## DEVELOPMENT APPLICATION ASSESSMENT REPORT

<b>Application Number:</b>	DA2022/0084
----------------------------	-------------

<b>Responsible Officer:</b>	Claire Ryan
<b>Land to be developed (Address):</b>	Lot 114 DP 8394, 73 Marine Parade AVALON BEACH NSW 2107
<b>Proposed Development:</b>	Demolition works and construction of a dwelling house, secondary dwelling and swimming pool
<b>Zoning:</b>	C2 Environmental Conservation C4 Environmental Living
<b>Development Permissible:</b>	Yes - Zone C2 Environmental Conservation Yes - Zone C4 Environmental Living
<b>Existing Use Rights:</b>	No
<b>Consent Authority:</b>	Northern Beaches Council
<b>Delegation Level:</b>	DDP
<b>Land and Environment Court Action:</b>	No
<b>Owner:</b>	Lincoln John Courtney Megan Jane Lynch
<b>Applicant:</b>	Sean Clive Gartner

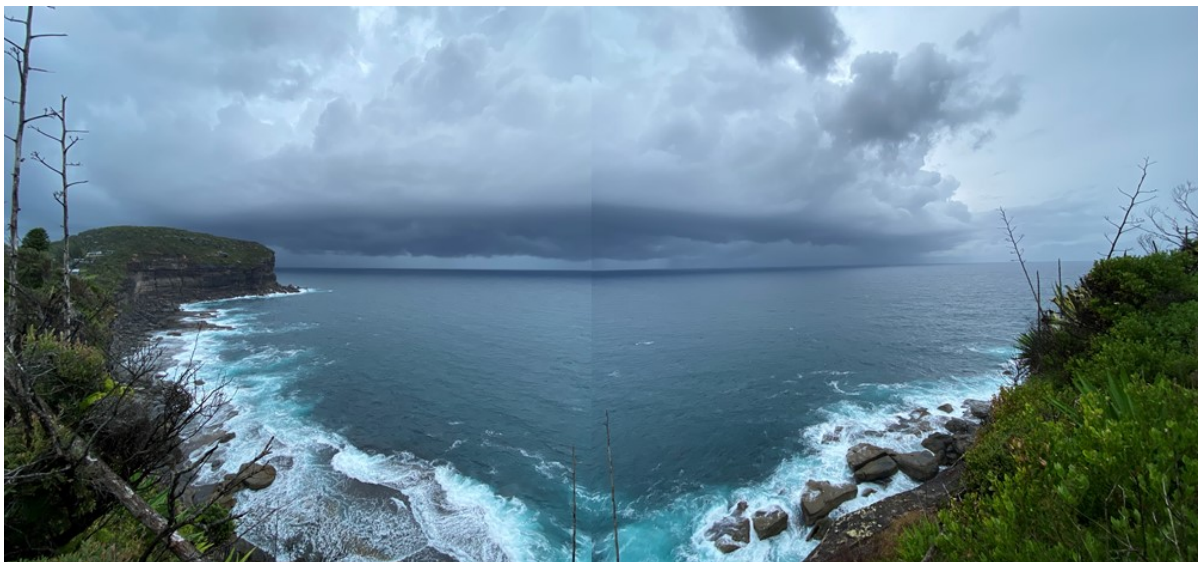
#### Comment to Principle 3:

The extent of impact views is described as follows:

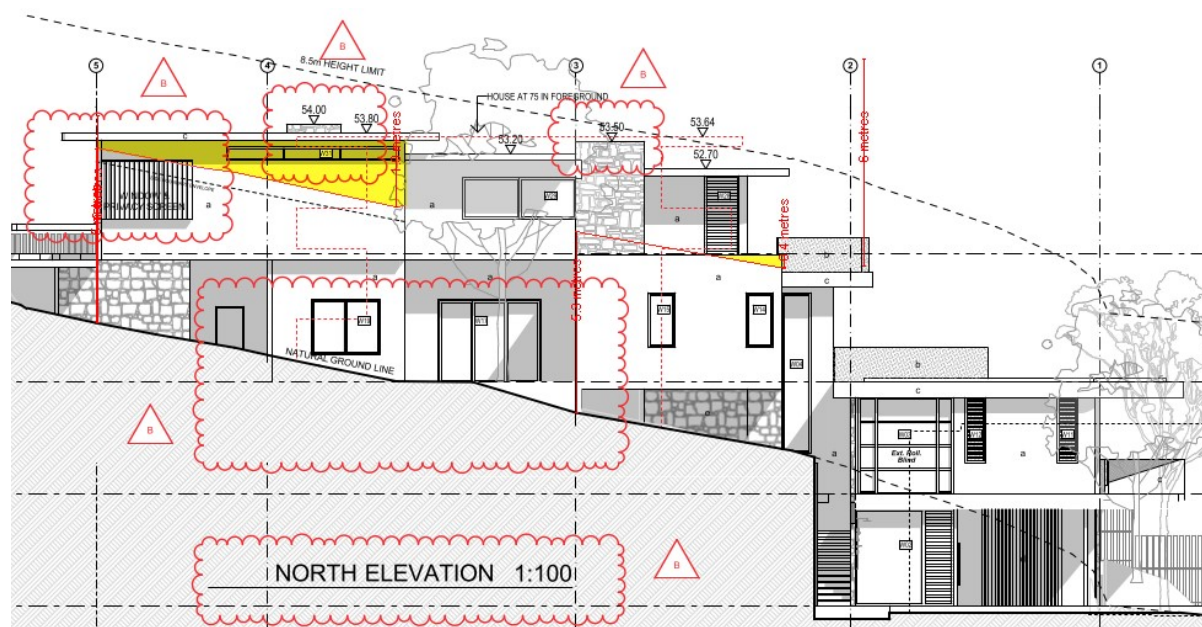
The proposed development includes breaches to the northern side boundary building envelope, by a maximum of 1.9m. The image below highlights the breaching points in yellow. The areas clouded in red indicate minor amendments to the plans and do not relate to the building envelope control breach.
